**U.S. ROUTE 5
HARTFORD AVENUE**

ADDENDUM #1: REVISED APRIL 18, 2007

PROJECT NAME:	HARTFORD	PLOT DATE:	4/18/2007
PROJECT NUMBER:	RS 0113(40)	DRAWN BY:	E. ATKINS
FILE NAME:	z86c027xsl.dgn	CHECKED BY:	K. ISHIKURA
PROJECT LEADER:	KEN UPMAL	SHEET	201 OF 239
DESIGNED BY:	K. ISHIKURA		
	E. ATKINS

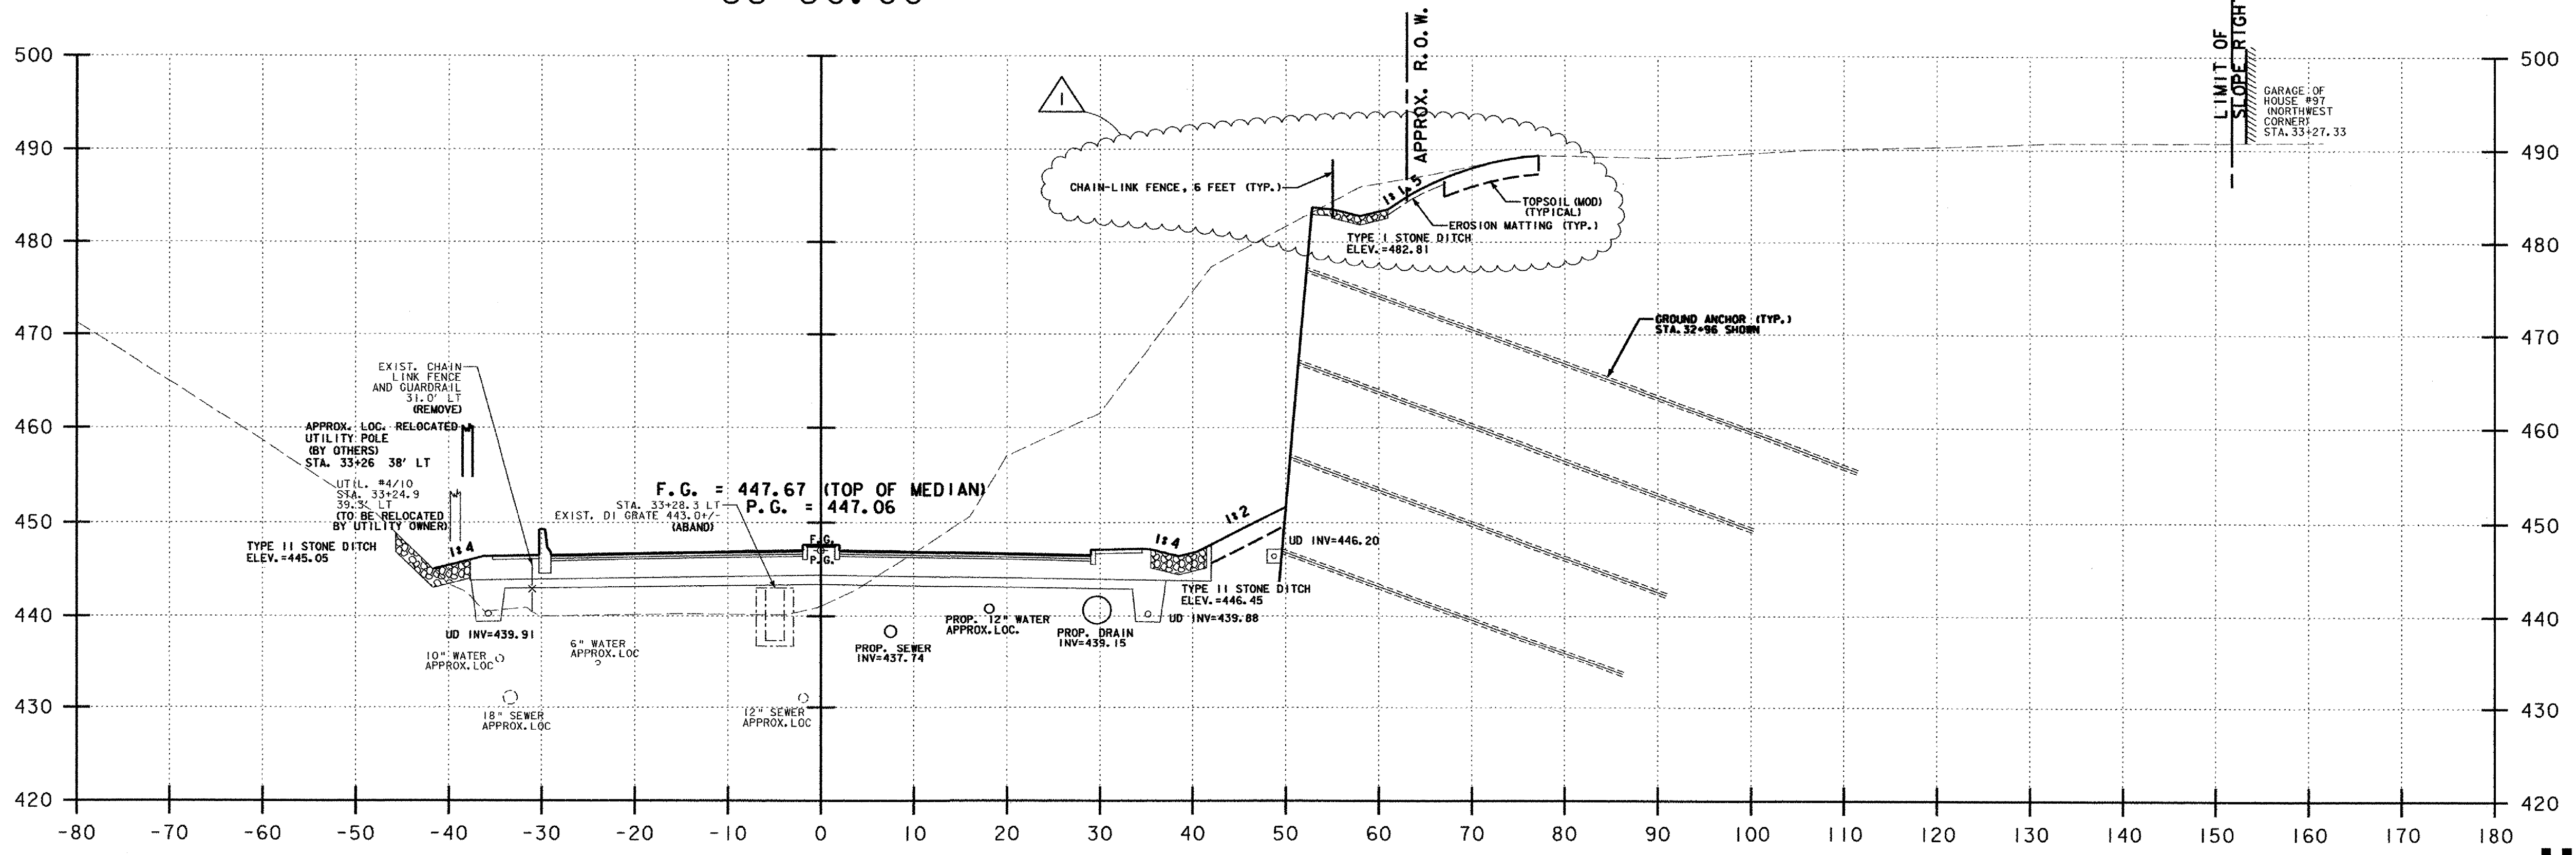
SEE VALUE ENGINEERING
RETAINING WALL
